## PLAN COMMISSION AGENDA ITEM EXECUTIVE SUMMARY

<b>Project Title/Address:</b>	Appeal of Administrative Design Review Decision – 828 S. 3 <sup>rd</sup> Street		
<b>City Staff:</b>	Ellen Johnson, Planner Russell Colby, Planning Division Manager		
<b>PUBLIC HEARING</b>		<b>MEETING 5/16/17</b>	X

RE: Permit No. 17-24970 / 828 S. 3<sup>rd</sup> St. (New house in RT district)

RE: **Super Bad** – Appeal of Administrative Design Review Decision  
828 S. Third St.  
Permit #: 17.24970  
LGI# 2015-0135

**EXTERIOR ELEVATIONS**

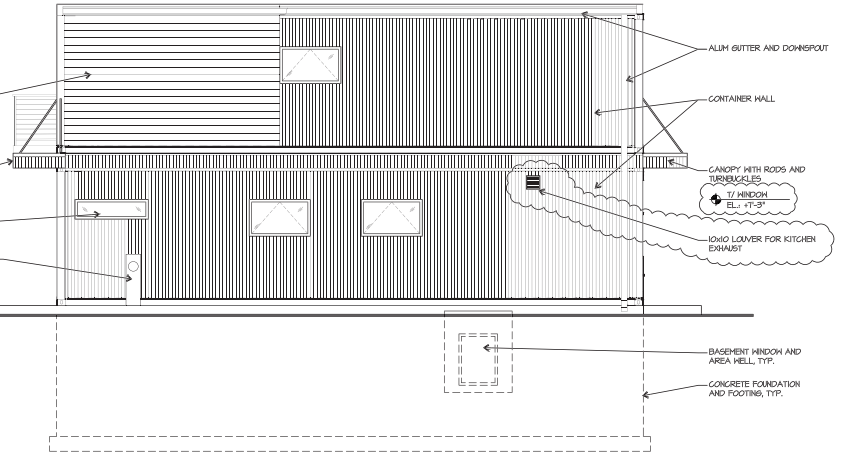
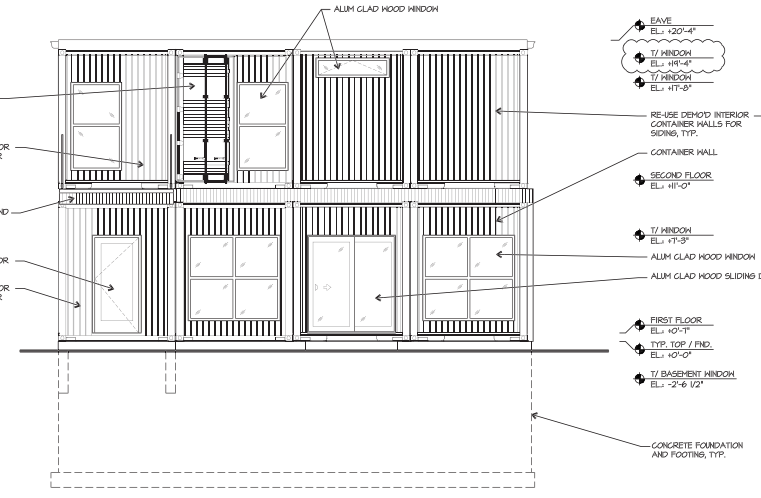
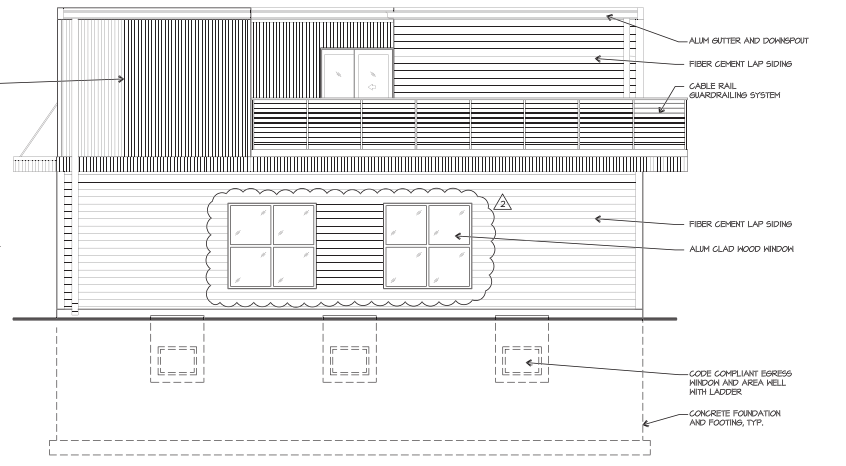
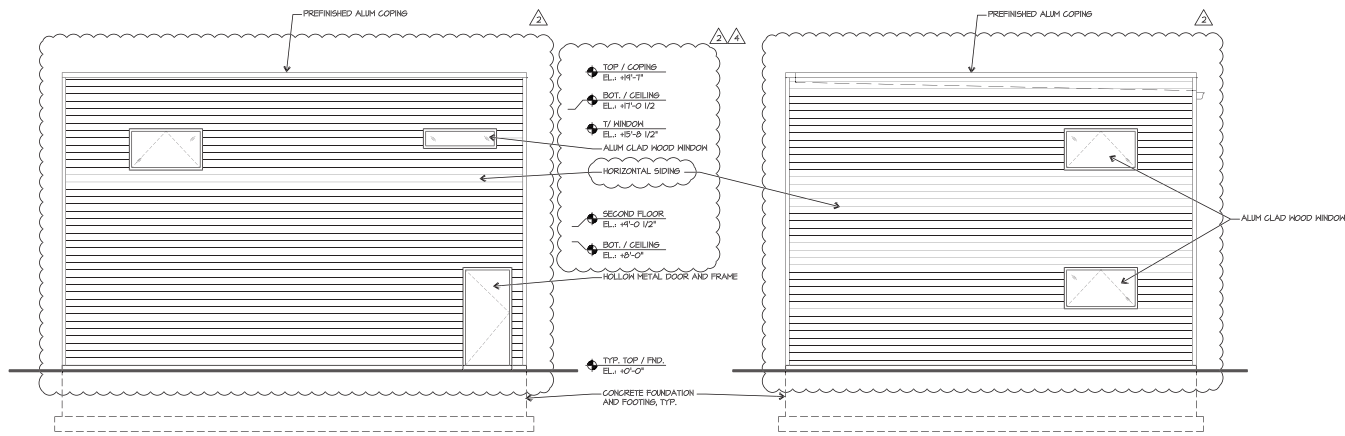
City staff have received and reviewed the letter from Kaleb Yanko dated 5/11/17 and the revised elevation drawings. We acknowledge the following two changes have been made to the plans:

1. The second floor balcony has been pushed forward to project over the first floor on the front elevation.
2. The colors of the home have been modified.

However, these changes do not address staff's previous comments related to compliance with the Design Standards and Guidelines of Chapter 17.06, specifically the Design Standard concerning 360-degree architecture. The ordinance states,

- a. Materials are not consistent on all elevations. The fiber cement siding used on the side elevations should be incorporated on at least part of the front and rear elevations.
- b. Window openings and panes should be similarly proportioned throughout and should be placed in a manner that creates a balanced elevation on all sides of the house. As currently drawn, window openings are not balanced; a variety of window types and sizes are proposed and window positioning is inconsistent. This is of particular concern on the front elevation.
- c. While we understand the shipping container doors are part of the container, we feel they are not appropriate for a residential structure in a Traditional Residential zoning district. Consider removing the container doors and/or handles/hardware.

**EXTERIOR ELEVATIONS**

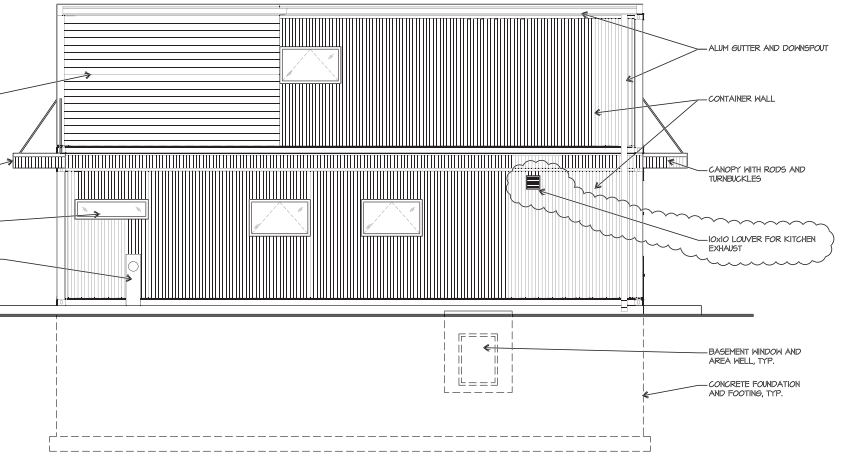
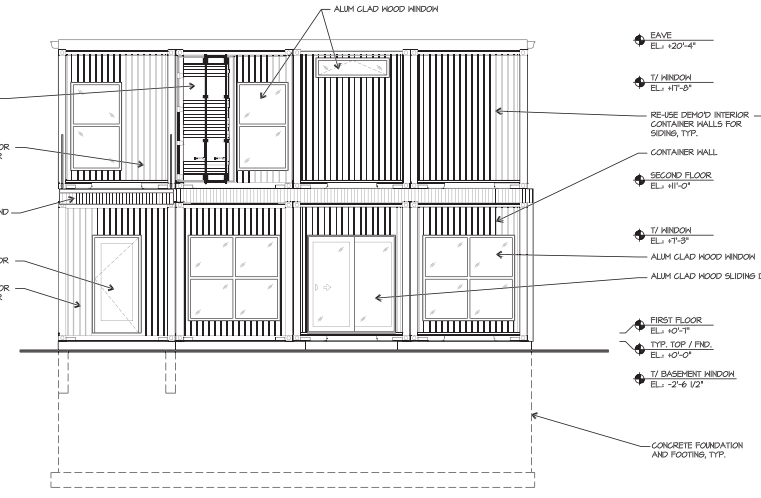
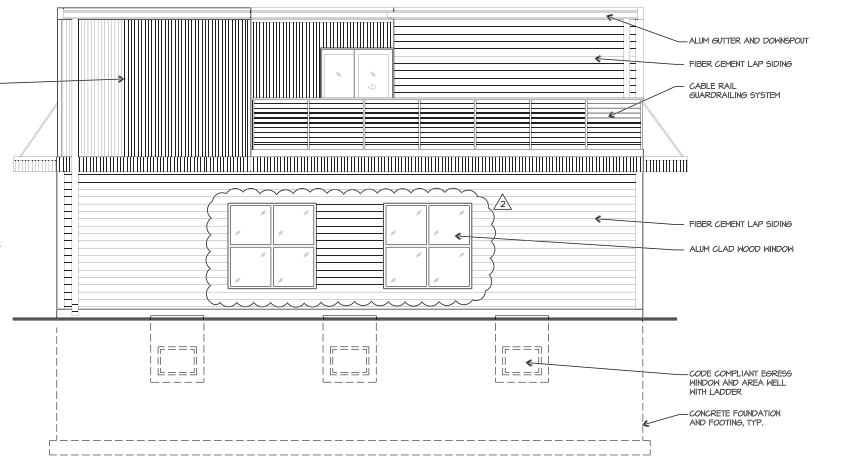
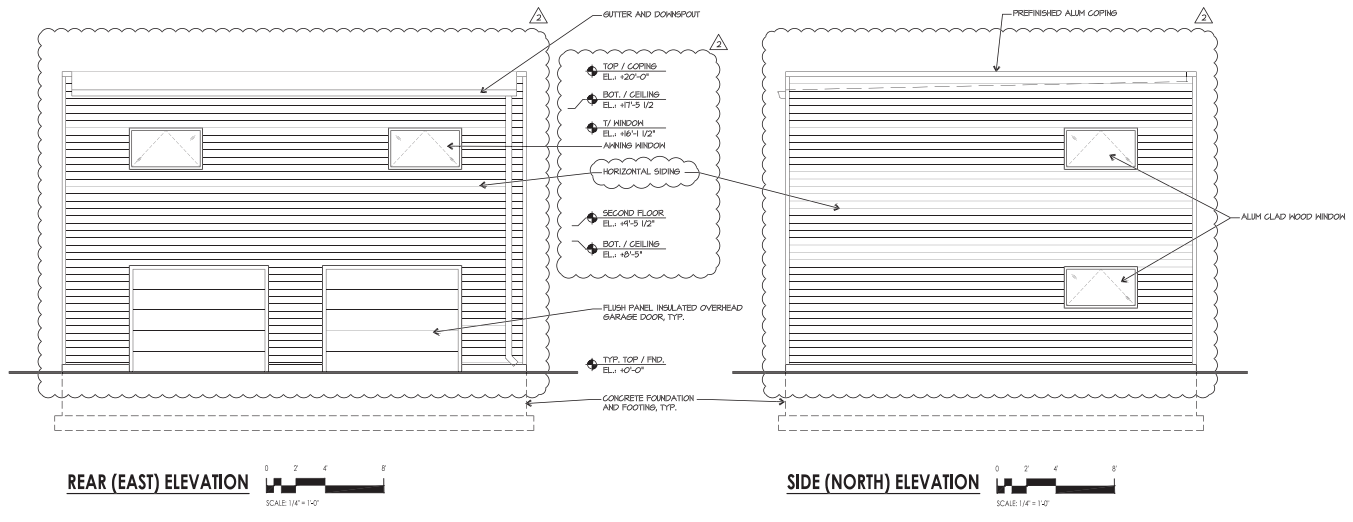
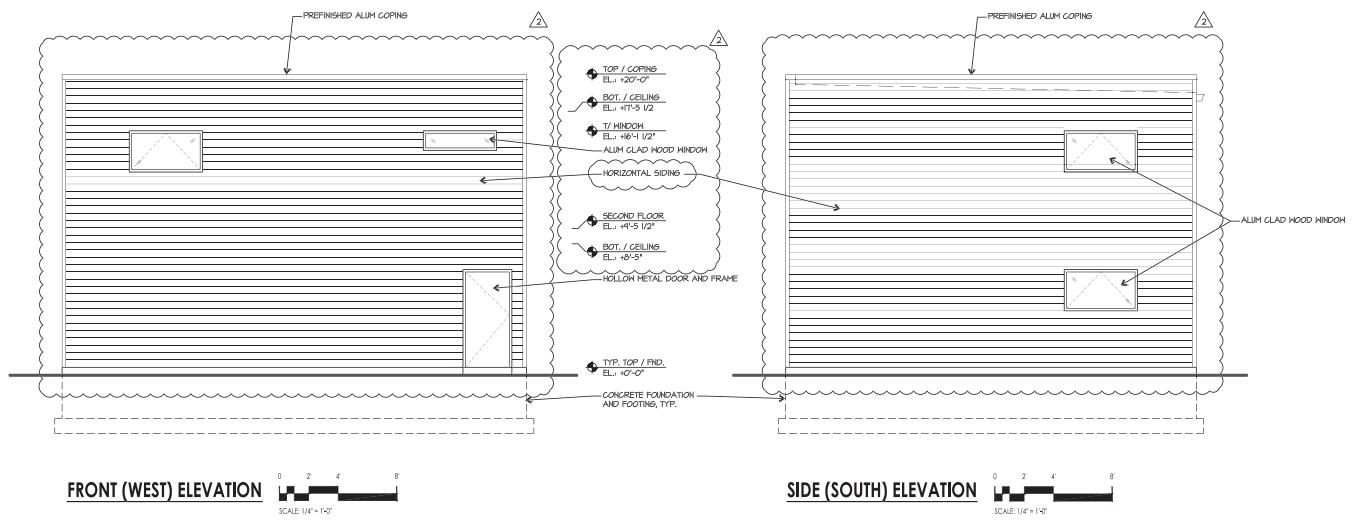
- a. *“Materials are not consistent on all elevations. The fiber cement siding used on the side elevations should be incorporated on at least part of the front and rear elevations.*

- b. *Window openings and panes should be similarly proportioned throughout and should be placed in a manner that creates a balanced elevation on all sides of the house. As currently drawn, window openings are not balanced; a variety of window types and sizes are proposed and window positioning is inconsistent. This is of particular concern on the front elevation.*

- c. *While we understand the shipping container doors are part of the container, we feel they are not appropriate for a residential structure in a Traditional Residential zoning district. Consider removing the container doors and/or handles/hardware.*

- d. *Because non-conventional materials are being used, please provide the proposed exterior colors and paint finishes so that we can better assess whether the design will be compatible.”*

- Item #1a The "modern" design aesthetic of the container home lends itself to asymmetrical features, textures, patterns and materials.
- Item #1b The front elevations has been discussed between the owner and City and determined that no changes are required. The side (north) elevation has been revised with windows that match the rear elevation.
- Item #1c Form follows function and the use of the container doors lends the to the structure's design theme. Make something that is useful – artful.
- Item #1d The colors that will be used are BAADF Limco Supreme Plus #ORSO1 and #BLU096.
